Project No. 0922.1-M242-E12

Subject: **Update to Geotechnical Investigation Report**
MPWMD – ASR Site Expansion
Backflush Pit at Santa Margarita Well Site
1910 General Jim Moore Boulevard
Seaside, California

Reference: **Pacific Crest Engineering, Inc.**
Geotechnical Investigation For New Electrical & Chemical Feed Building
Project No. 0922-M242-E12
Dated April 30, 2009

FIGURE 1

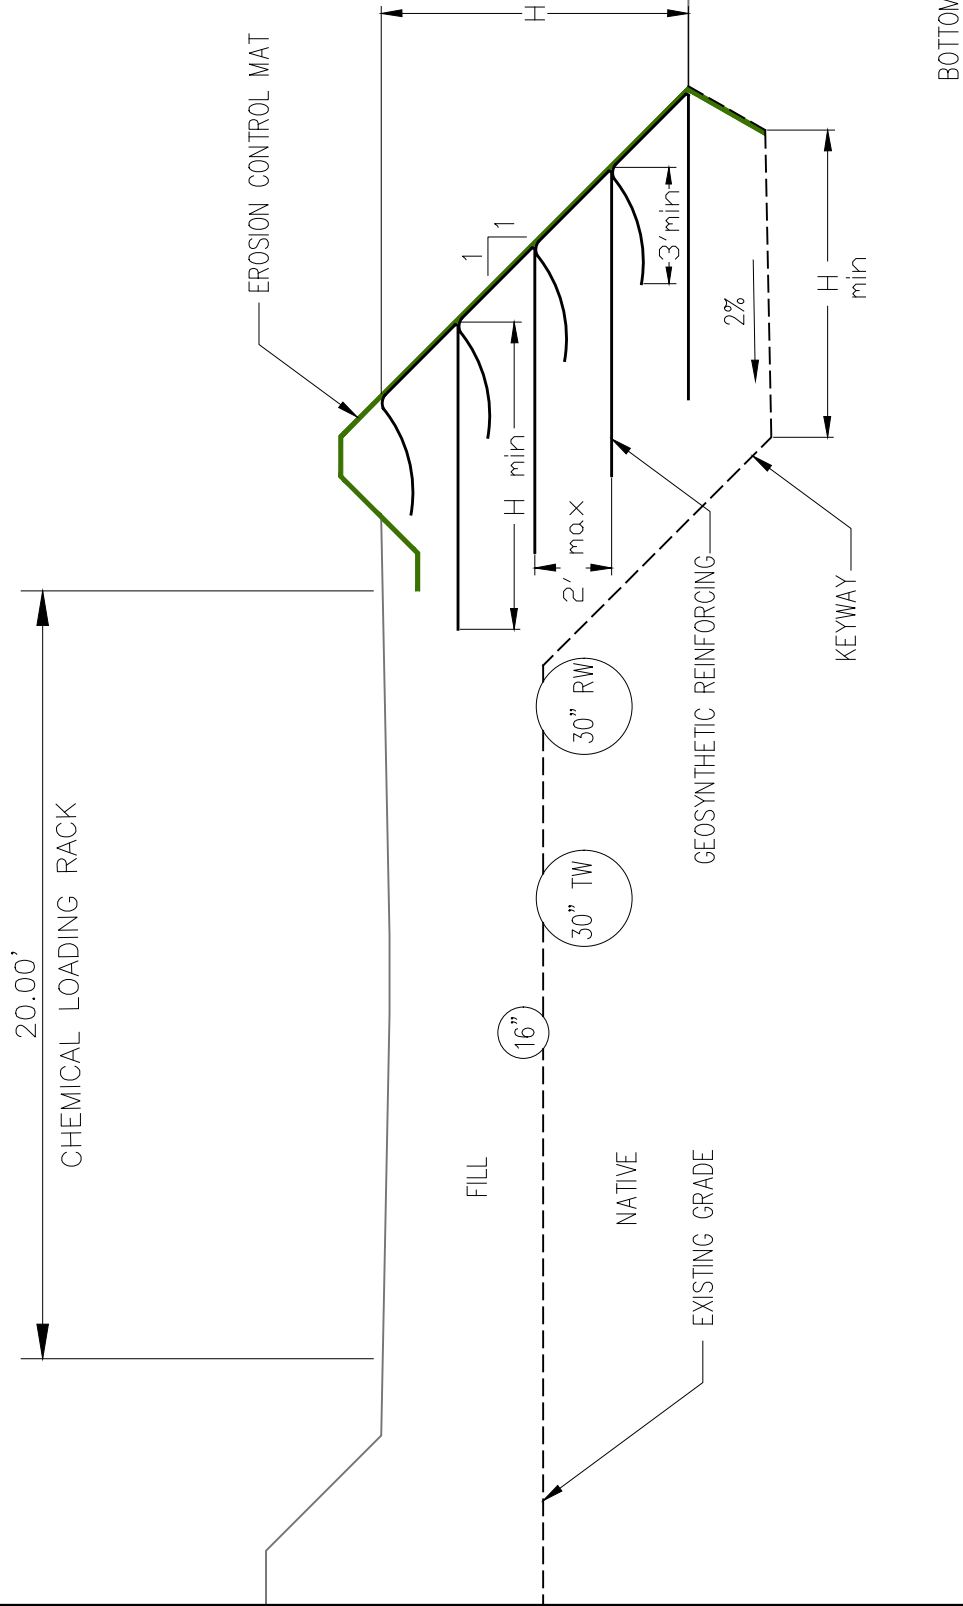
The proposed pond expansion will require raising existing grades along the north and west sides with up to 4 to 5 feet of fill. In addition, existing grades at the base of the expanded pond will be lowered by about 5 to 6 feet. This will create a condition where the pond slopes will be comprised of cut overlain by fill. As recommended in the soil report, fill slopes to be constructed above cut slopes should be set back a minimum of 8 feet horizontally from the top of the cut slope. This is especially important where structural improvements such as the chemical loading rack, new access roads or new utility corridors will come within close proximity to the pond slopes. Alternatively, the slope below the chemical loading rack pad may be constructed of engineered fill at a maximum gradient of 2:1 horizontal. The fill slope should be constructed in accordance with the recommendations of the 2009 geotechnical report and Figure No. 1 attached.
